Architectural Review Board Staff Report

Meeting Date: November 2, 2023
Report #: 2309-1978

739 Sutter [23PLN-00201]: Request for a Streamlined Housing Development Review to Allow the Construction of an Approximately 18,000 Square Foot (sf) Multi-Family Project Consisting of 12 Three-Bedroom Condominium Units in 3-story Buildings on an Approximately 0.38-acre (16,707 sf) Parcel. The Project would replace an existing 8-Unit Residential Rental Building. The Project includes two Units Provided at Below Market Rate and, Accordingly, Requests Concessions and Waivers Pursuant to State Density Bonus Law. Environmental Assessment: Exempt from the Provisions of the California Environmental Quality Act in Accordance with CEQA Guidelines Section 15332 (in-fill development). Zoning District: RM-20 (Multiple-Family Residential). For More Information Contact the Project Planner Claire Raybould at Claire.Raybould@cityofpaloalto.org

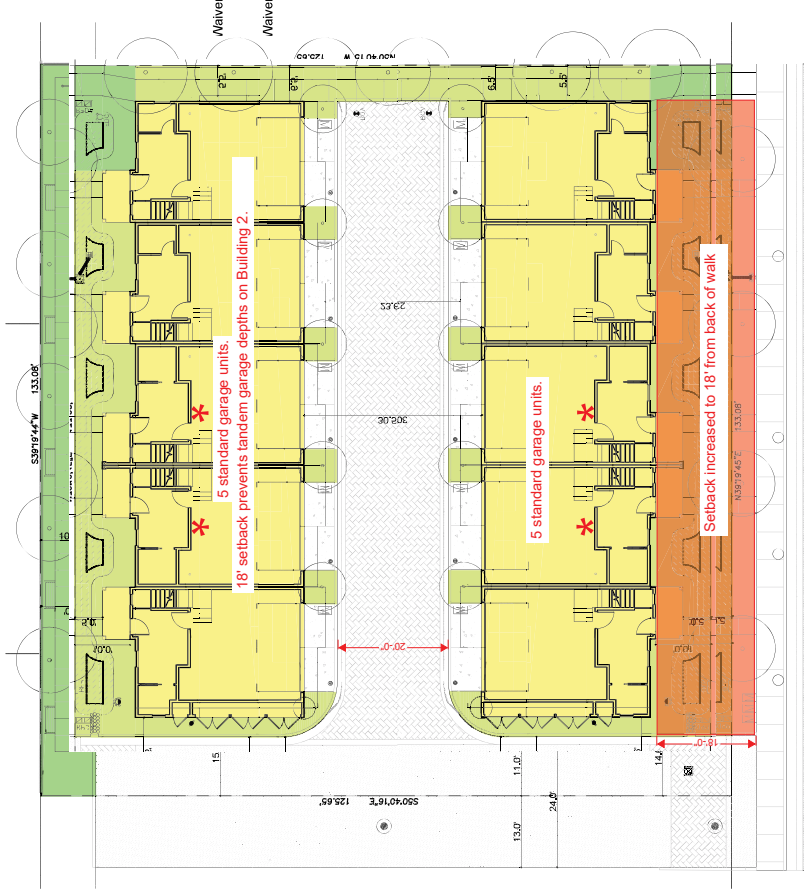
**PROPOSED PLAN
12 UNITS w/ 14' SETBACK.**

**HYPOTHETICAL CODE COMPLIANT PLAN
10 UNITS w/ 18' SETBACK.**

AREA DIAGRAMS WAIVER DIAGRAM 10 - INDIVIDUAL RESIDENTIAL ENTRY WIDTH - PAMC Sec. 18.24.060(c)(4)(A)(i)(a)

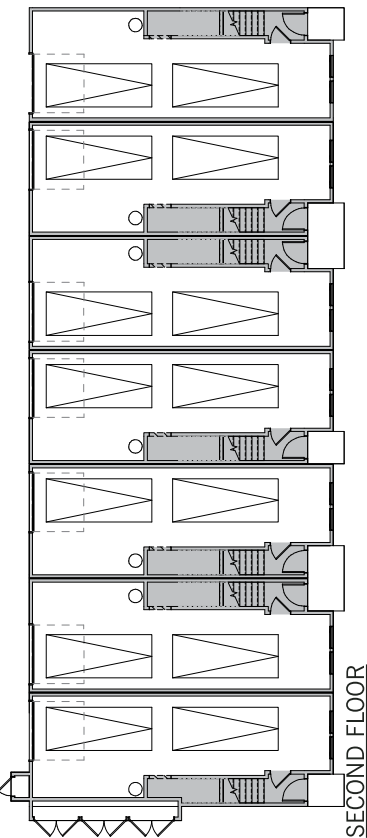
Waiver. A minimum entry width of 4'-0" is required. Building 1 complies. Literal application of this standard on Building 1 would preclude all proposed tandem units by conflicting with minimum garage dimensions and would result in a reduction of 14 SF of proposed building area. This reduction in building area is the equivalent of eliminating .1 of the density bonus project's proposed units.

BUILDING 1 ELEVATIONS CONCESSION DIAGRAM 1a - BUILDING HEIGHT - PAMC Sec. 18.13.040(a)

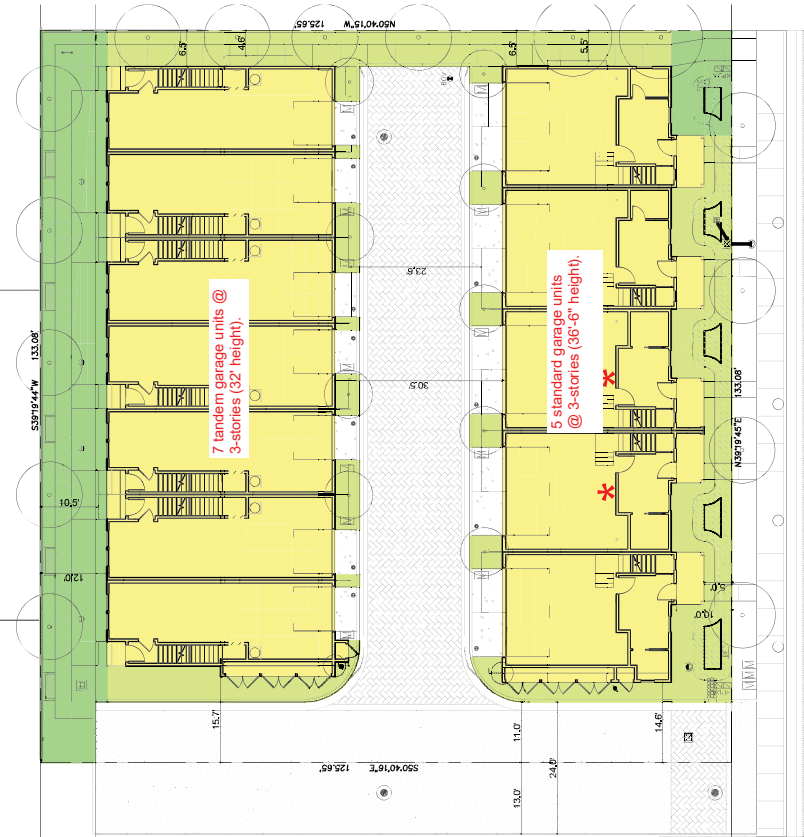
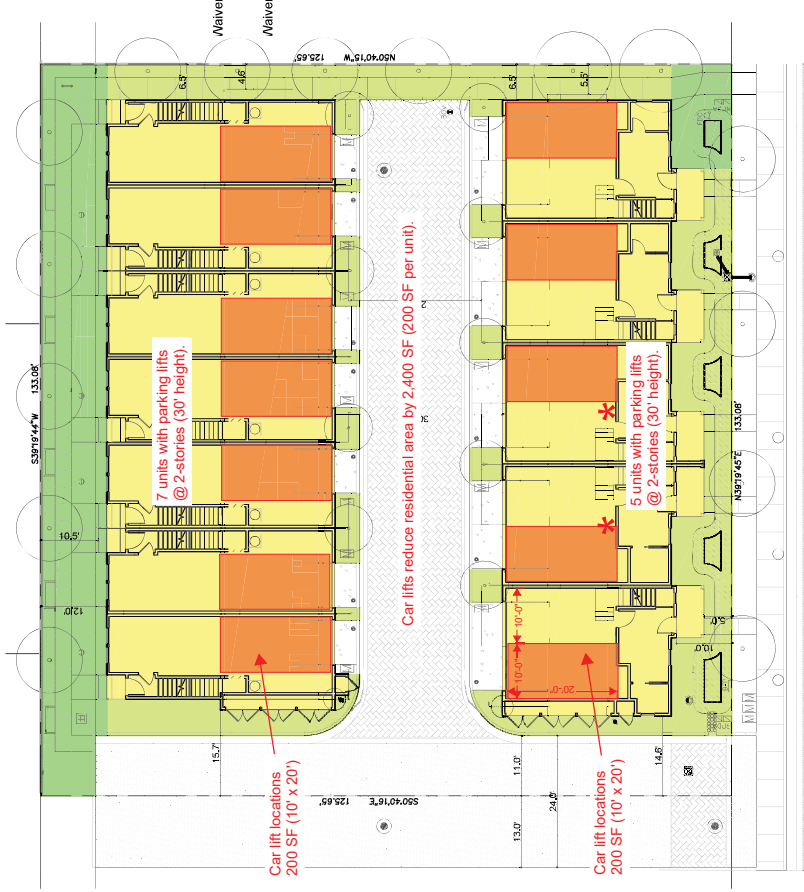
Concession 1a to allow for 36'-6" maximum building height where 30' maximum is permitted. Three story building height is necessary to achieve the density bonus projects proposed unit count (12 units), and residential area (18,088 SF). Garage area requires the majority of one floor (level 1), living area and dining area requires another floor level (level 2), bedrooms require a third floor level (level 3). Installation of underground pits and parking lifts was explored to comply with building height. Complying with the 30' height limit is estimated to increase the cost of construction by \$1,500,000 and would reduce residential area by 2,400 SF (200 SF per unit). Therefore, a concession from this requirement is merited. The property also qualifies for a height waiver to account for the concession. Literal enforcement of the height limit (without the concession) would conflict with the 3rd floor reduce the size of the project by 7,687 square feet, equal to 5 units.

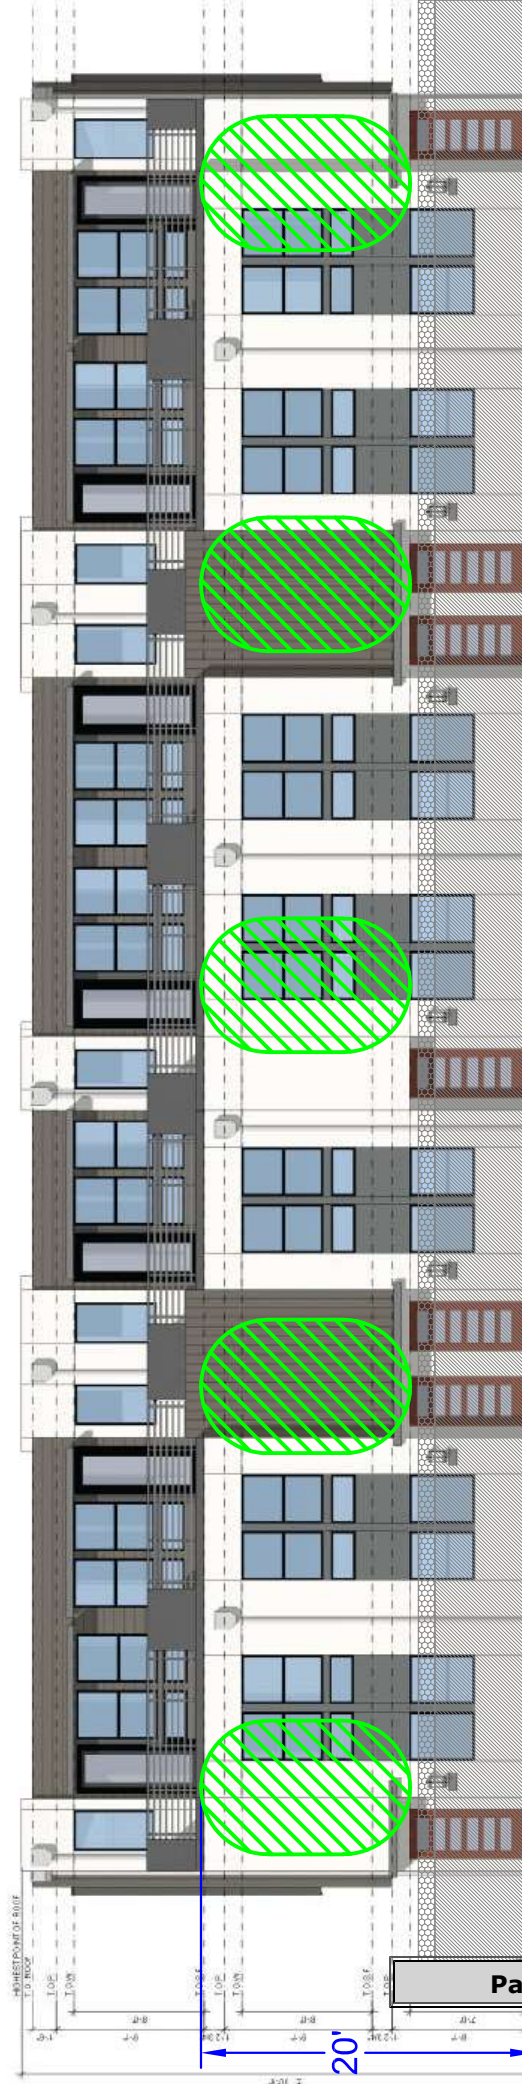
I've made the renderings based on websites of nurseries that sell *Podocarpus gracilior* in 24" box and larger sizes. Suffice it to say that there is considerable variation in initial sizes and shapes and indicated growth rates, so the renderings are rough estimates at best. I base the mature sizes on what's shown in the landscape architect's drawings: 40' height and 25' canopy width.

My understanding is that your comments about problems when planting larger trees are well founded. Moreover, addressing any problems with trees that fail to take root could be difficult given the limited access afforded by the 12' setback. But I think it's worth asking what might happen with trees in 36" box size or larger; if they don't work, why do nurseries sell them?

It may well be that privacy issues are largely irrelevant under the density bonus law. I offer these renderings simply to illustrate that that the proposed trees afford no reasonable measure of privacy any time soon. Were these renderings superimposed on the picture on page 4 of the PDF that Jue Cheng submitted today, they would show that the trees would have little effect on the view from 746 San Carlos Ct. for many years.
